ADDENDUM #1 - 6/16/2025
REVISED SHEETS: D-1, D-2, D-7, INT-2, INT-3, P-1, P-2, P-4, U-1, U-2, U-3, U-5, U-6, U-12, U-13, U-14, U-15, W-1, W-2, W-5, W-7, E-1, E-2, E-4, E-7, AND E-8.
REVISION #1 - 8/28/2025
REVISED SHEETS: D-6, INT-2, INT-3, INT-4, INT-6, INT-7, ALL P SHEETS, U-1 TO U-6, U SCHEDULES, W-1 TO W-7, ALL E SHEETS, ADDED PM-13A, AND ALL X SHEETS.

E. MAIN STREET & S. HANCOCK STREET
ASSESSMENT DISTRICT - 2025

CITY PROJECT NO. 15125
CONTRACT NO. 8784

15125
D-1

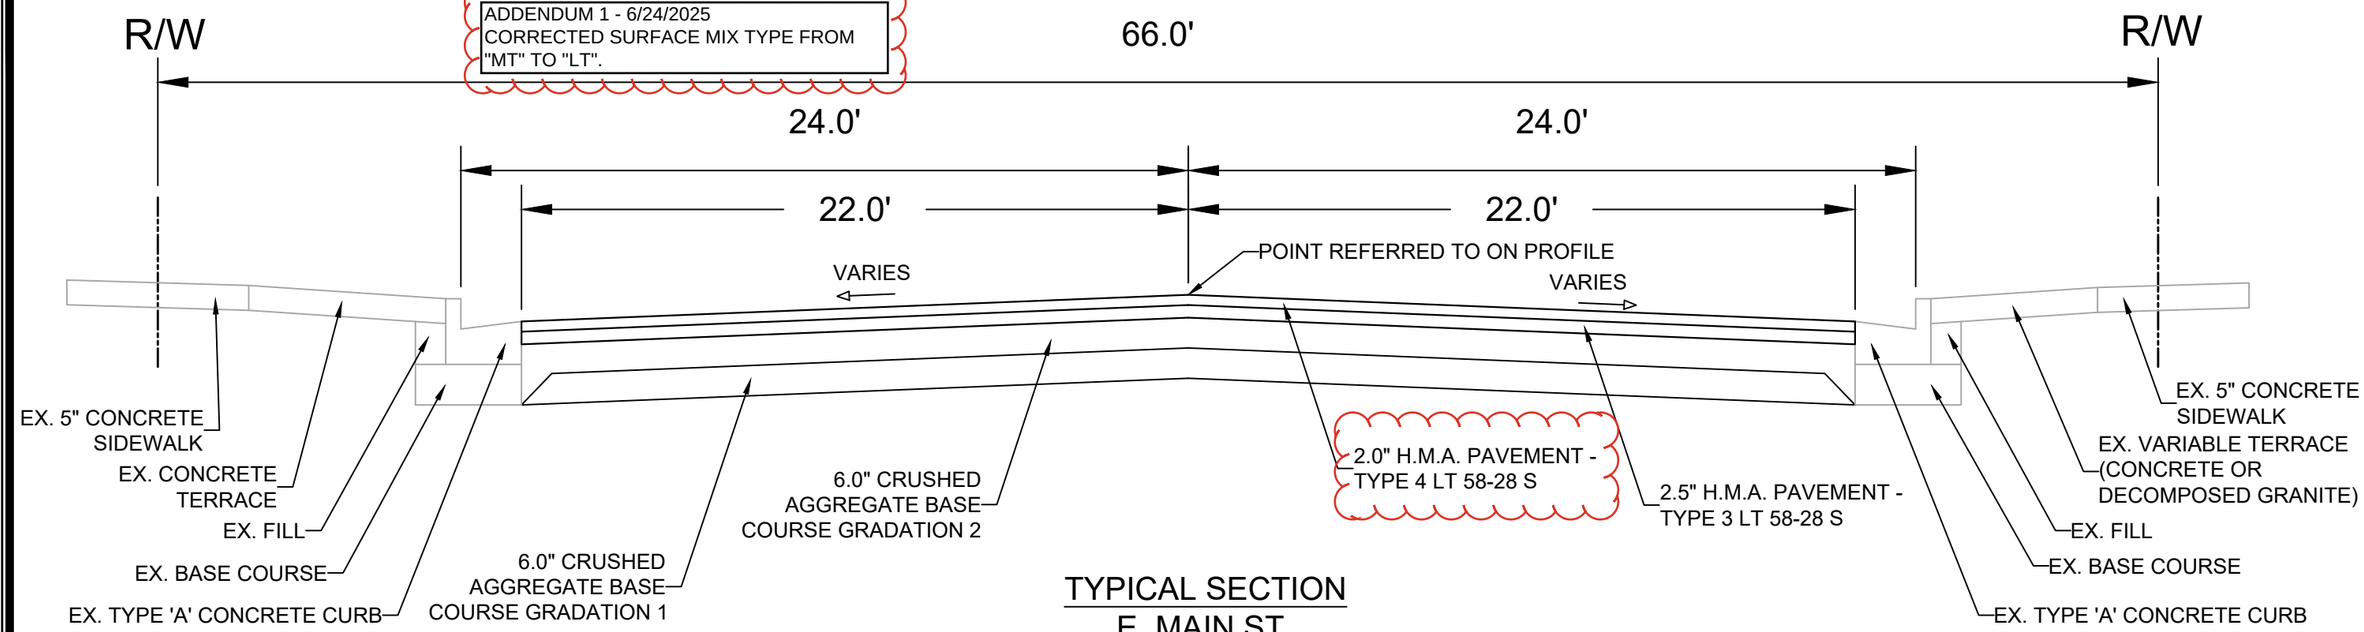
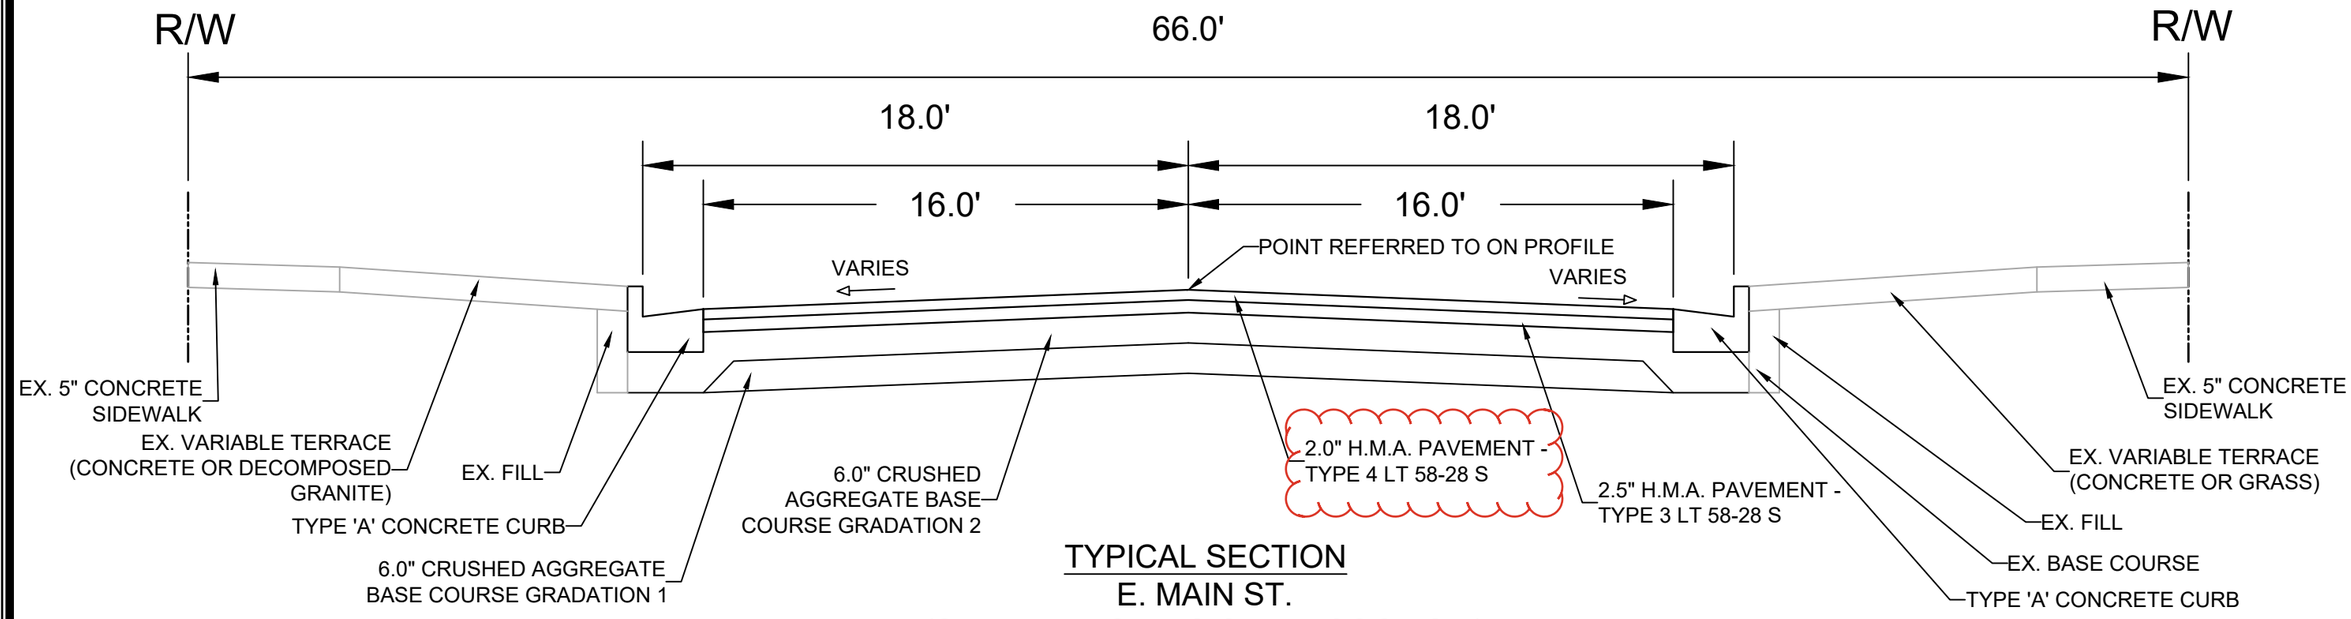
ADDENDUM 1 - 6/24/2025
CORRECTED SURFACE MIX TYPE FROM "MT" TO "LT".

15125
D-2

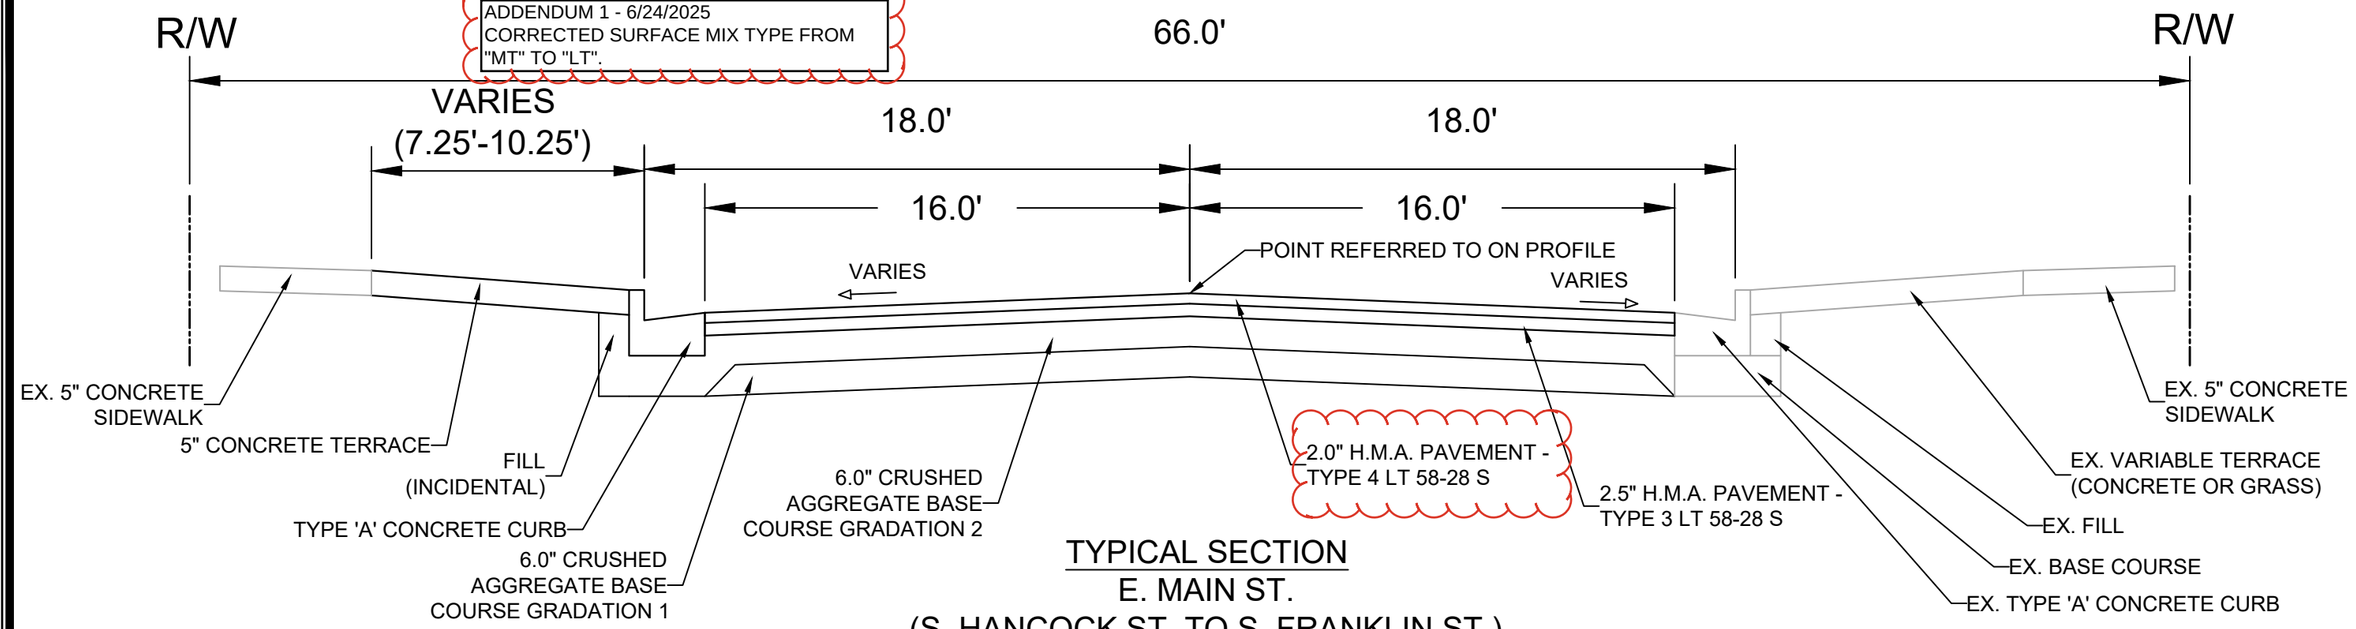
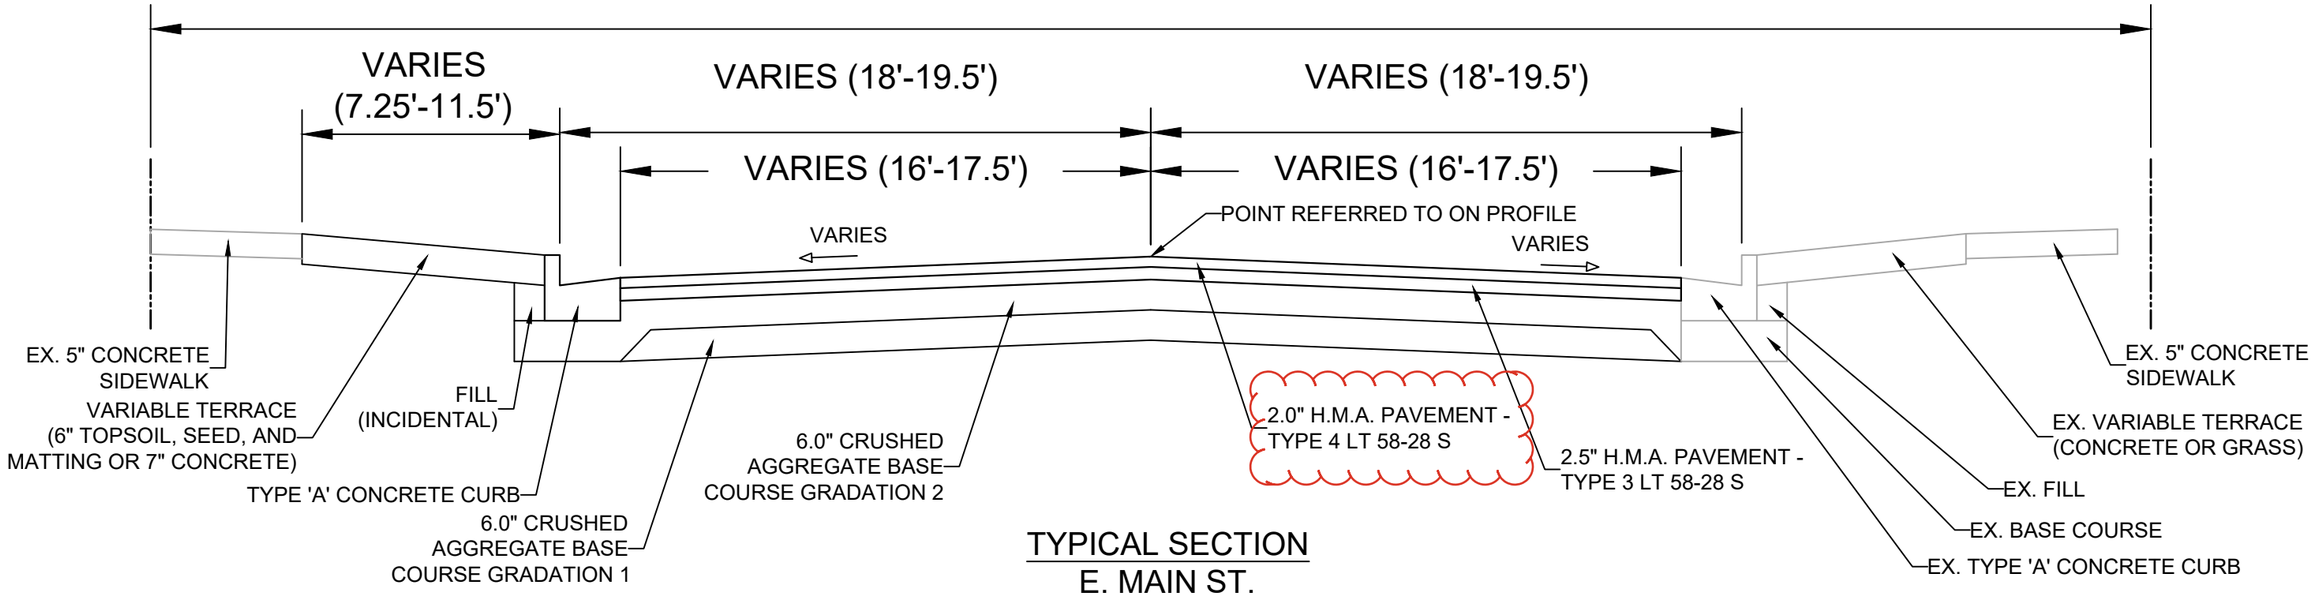
ADDENDUM 1 - 6/24/2025
CORRECTED SURFACE MIX TYPE FROM "MT" TO "LT".

15125
D-7

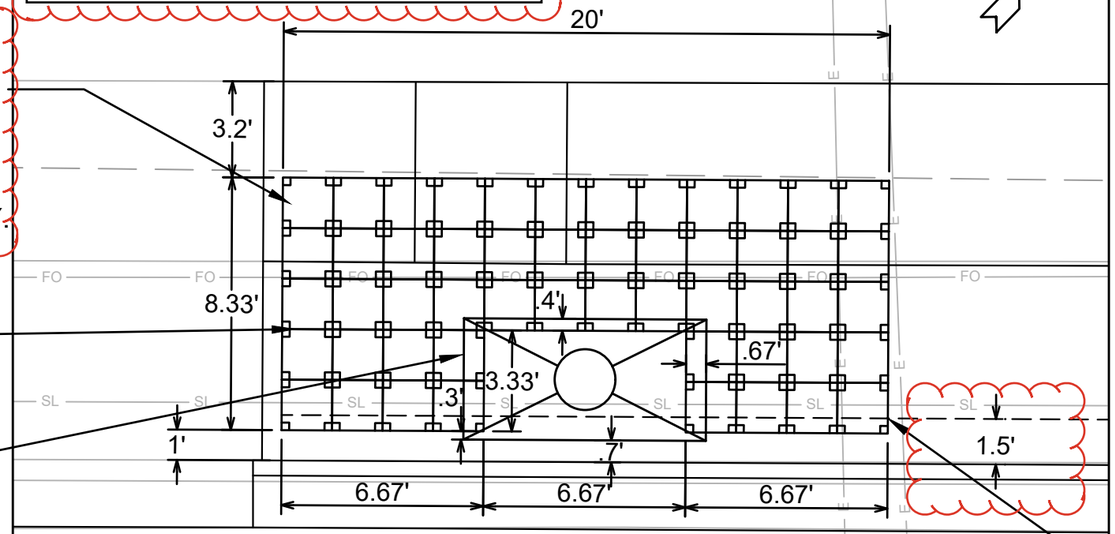
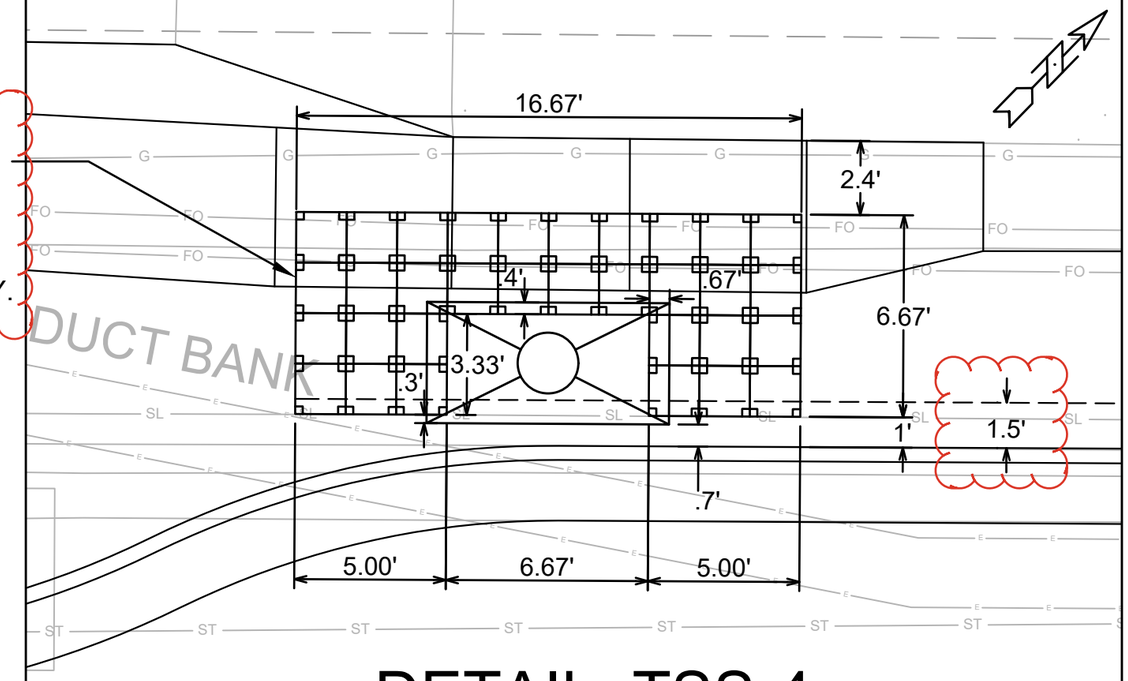
ADDENDUM #1 - 6/24/2025
1. REVISED CALCULATIONS FOR TERRACE SUPPORT SYSTEMS AND PLANTING MIX TOPSOIL.
2. ADDED UNDERDRAIN FOR TSS-2, TSS-3, AND TSS-4.

UNDERDRAIN (SEE S.D.D. 4.05 FOR DEPTH)
NOTE: TSS-1 DOES NOT GET UNDERDRAIN

PLAN & PROFILE - S HANCOCK ST

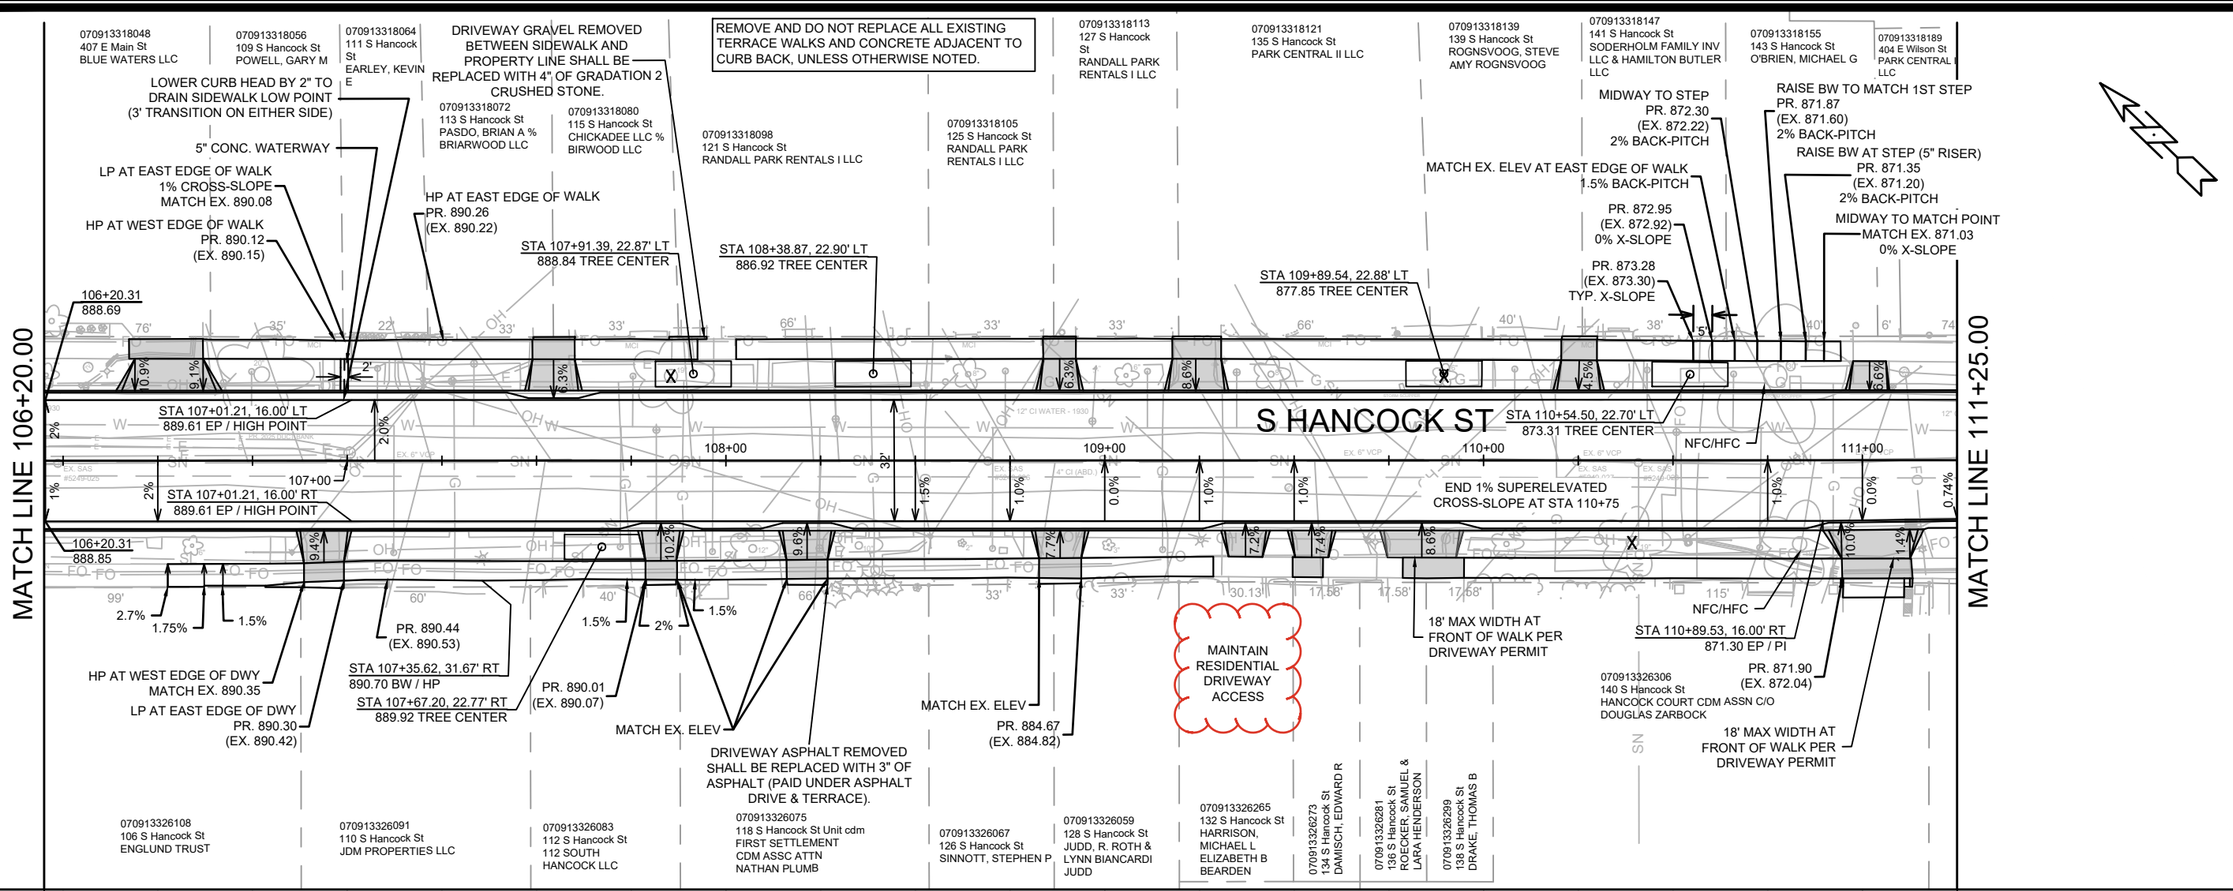
REVISION #1 - 8/28/2025
CHANGED CENTERLINE AND CURB GRADES, INCREASED SIDEWALK REMOVAL, CHANGED CROSS SLOPES, AND ADDED "MAINTAIN RESIDENTIAL DRIVEWAY ACCESS" FOR 132 S HANCOCK ST.

PM-7

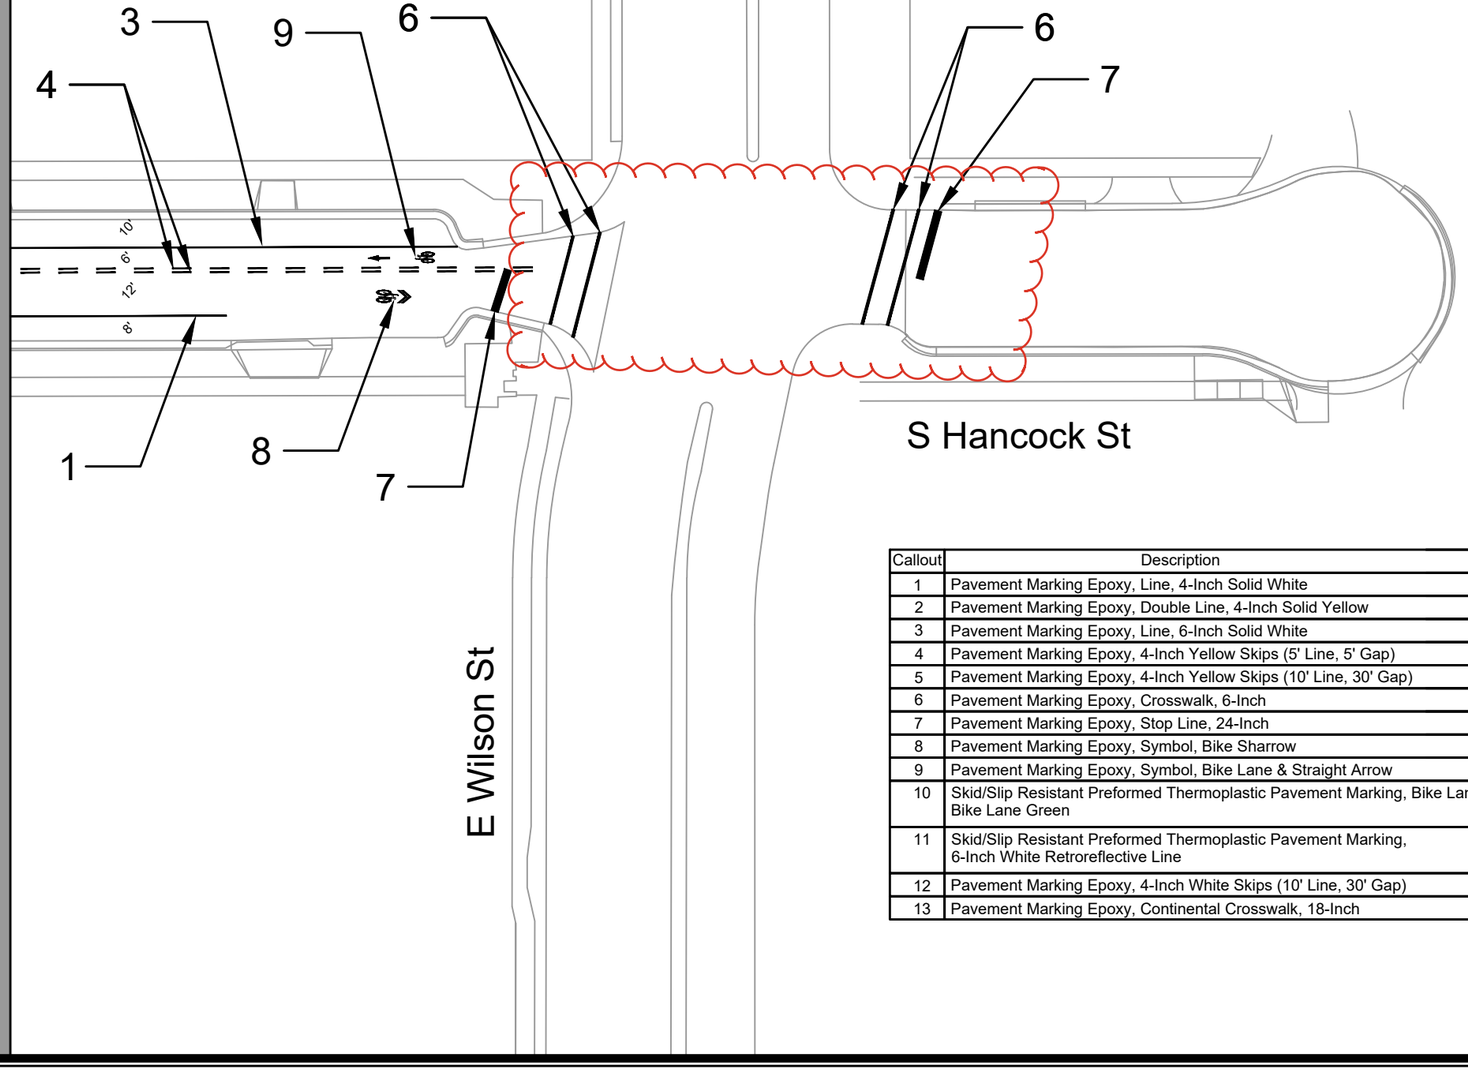
ADDENDUM 1 - 6/24/2025
1. INCREASED CURB REMOVAL/REPLACEMENT ON SOUTHWEST SIDE OF S. HANCOCK STREET.
2. ADJUSTED CROSSWALK MARKINGS TO MATCH EXISTING GEOMETRY.
